ADDENDUM 3 – JOB 13

TO: All prospective bidders on project SOIB-7-058(013)000, Job No. 13 scheduled for the February 5, 2016 bid opening.

**ADDENDUM 3
JOB NO. 13**

SOIB-7-058(013)000, PCN 20416

Existing Typical Section
ND 58
Jct 200 to Jct 1804

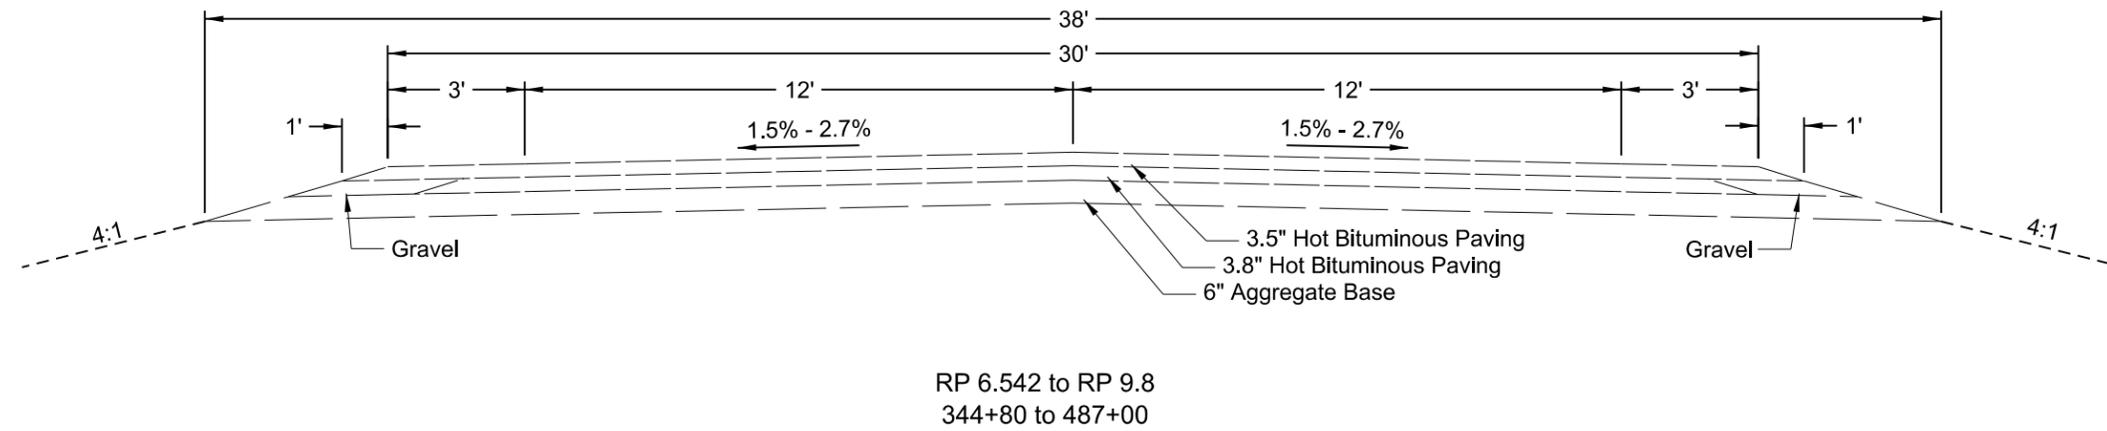
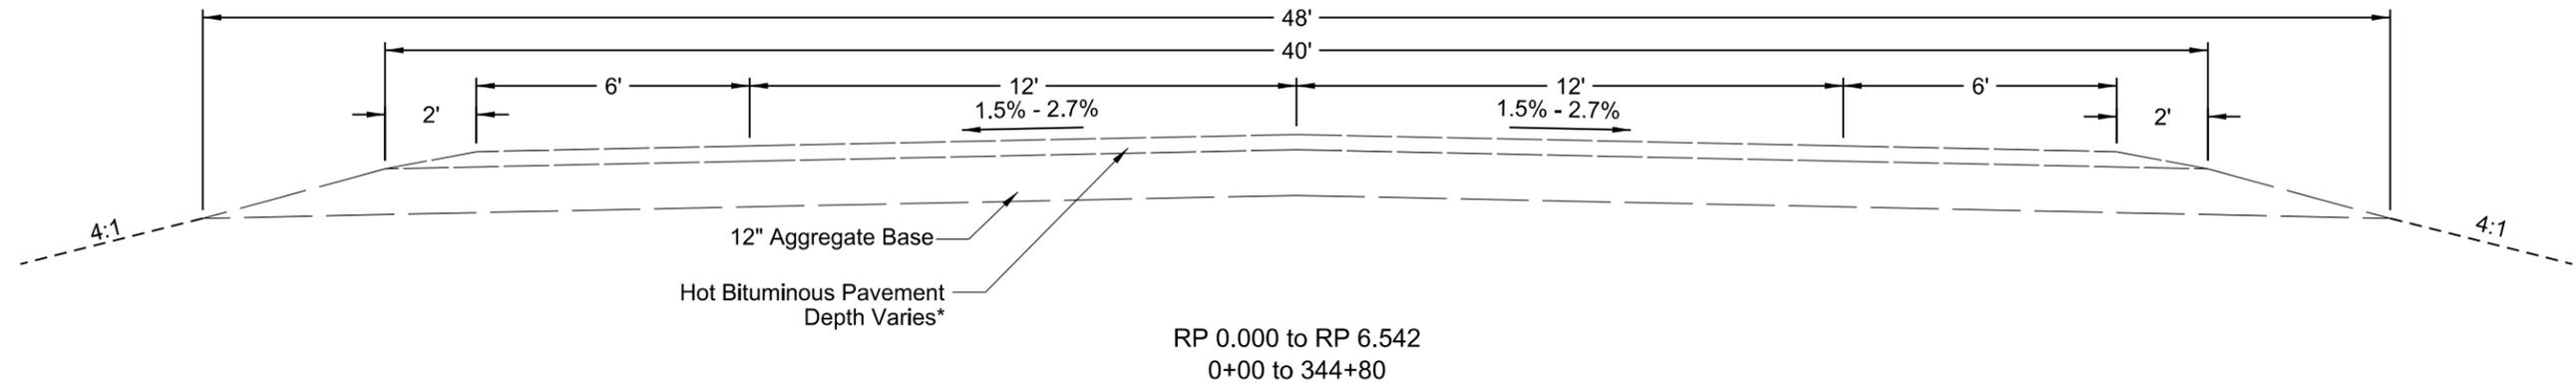
Section 30, Sheet 1: The Hot Bituminous Pavement thickness was changed to "Varies" from Station 0+00 to 344+80 with a note referring to data provided in the Boring Logs.

*See Boring Logs, provided as Supplemental Data
